Response to Submissions Report – Newcastle Power Station, Tomago (SSI-9837)

**Newcastle Power Station Project (CSSI 9837) Response to Submissions
Further Information Still Required by the Environment Protection Authority**

AGL - NEWCASTLE POWER STATION (SSI-9837)
OLD PUNT ROAD TOMAGO - Response to Submissions

APPLICATION NO: SSI 9837 (Our Ref. 25-2019-3-1)

Figure 6.3: ISR vs in-stack NO_x concentration from filtered US EPA ISR database

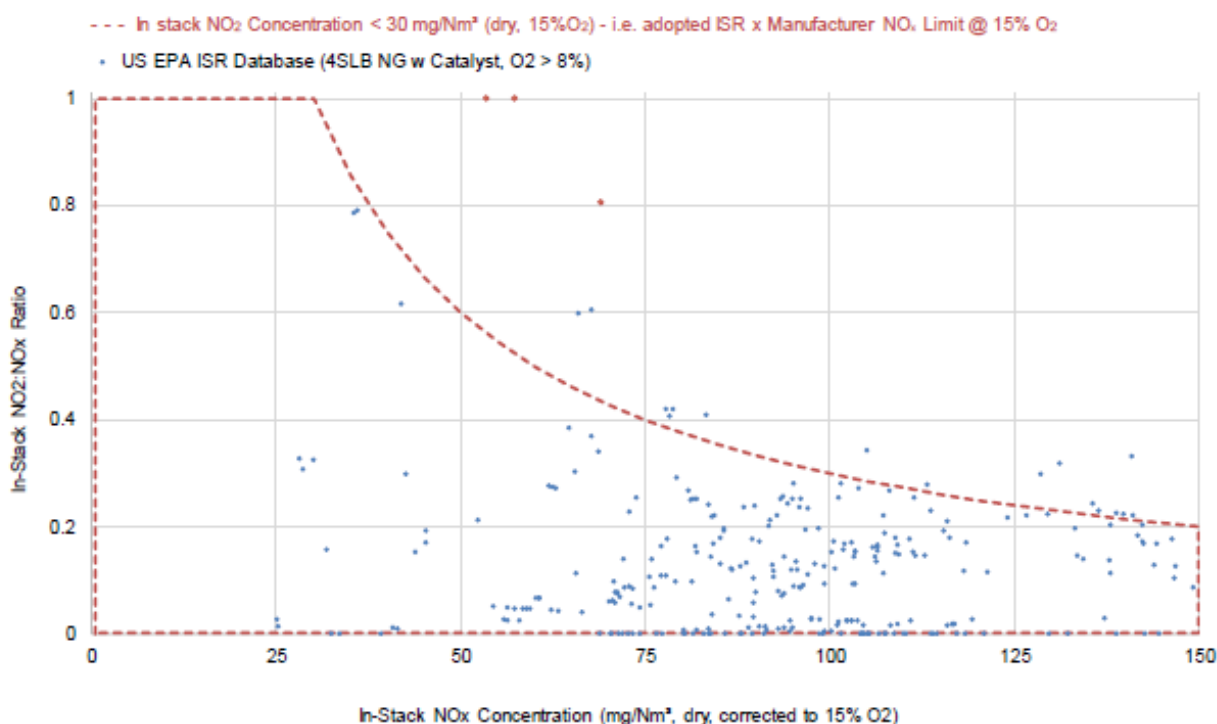
The benchmarking of control technology and NO_x emissions has not considered the application of best available technology and achievable emissions levels from experience in other jurisdictions. Given that NO_x is an ozone precursor and that the proposed power station would be in an ozone non-attainment area, NO_x emissions should be as low as reasonably and feasibly achievable. Further, as NO_x is a precursor to secondary particle formation and the proposed power station would be in a PM_{2.5} non-attainment area, NO_x emissions should be as low as reasonably and feasibly achievable.

Achievable emission levels for NO_x have been demonstrated to be significantly lower than those referenced and proposed in the RTS AQIA benchmarking. This is demonstrated in the AQIA's figure 6.3 which shows in stack NO_x emissions, which are not necessarily best practice, are generally far less than 100 mg/m³ (@ 15 % O₂) and therefore the proposed 150 mg/m³ is not best practice (Figure 6.3 reproduced below).
